Access Compliance Report

Public Rights-of-Way

Intersection ID: 25850	Main Street: BLOCKADE_CT	Cross Street: CASTLEKEEP_RD	Location: SW
ADA ID: 4DC0518605E2	Ramp Type: Directional1	Initial Pass/Fail: Fail	Overall Compliance: No
		Severity Score: 25

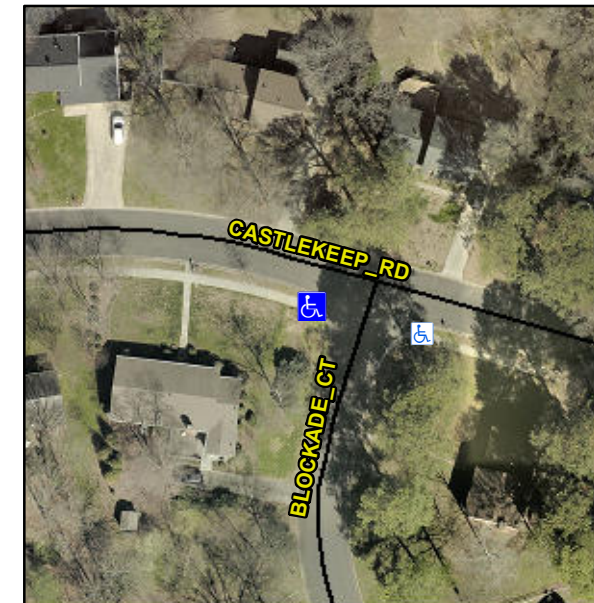
R304.5.3

Compliance	Description	Data	Compliance	Description	Data
N/A	Ramp Length (in)	79.0	N/A	Grade Break?	N/A
Yes	Ramp Width (in)	58.0	N/A	Grade Break Slope (%)	0.0
Yes	Ramp Slope (%)	8.2	N/A	Grade Break XSlope (%)	0.0
No	Ramp XSlope (%)	9.9			
N/A	Flare Type LT	N/A	N/A	Flare Type RT	N/A
N/A	Flare Slope LT (%)	N/A	N/A	Flare Slope RT (%)	0.0
N/A	Flare Traversable LT?	N/A	N/A	Flare Traversable RT?	N/A
N/A	Landing Length (in)	0.0	N/A	DWS Provided?	N/A
N/A	Landing Width (in)	0.0	N/A	DWS Contrast?	N/A
N/A	Landing Slope (%)	0.0	N/A	DWS Length (in)	N/A
N/A	Landing X Slope (%)	0.0	N/A	DWS Full Width?	N/A
N/A	Landing Curb? (Y/N)	N/A	N/A	DWS Offset LT (in)	N/A
N/A	Shared Landing?	N/A	N/A	DWS Offset RT (in)	N/A
N/A	Gutter Ponding?	0.0	N/A	Gutter Slope (%)	N/A
N/A	Gutter Lip Ht (in)	0.0	N/A	Gutter X Slope (%)	N/A
N/A	Painted X Walk1?	No		Road Slope (%)	4.2
	X Walk 1 Direction	To E		Road X Slope (%)	8.7
	X Walk 1 Width (in)	N/A		Clear Space?	N/A

Remove & Replace Entire Ramp.
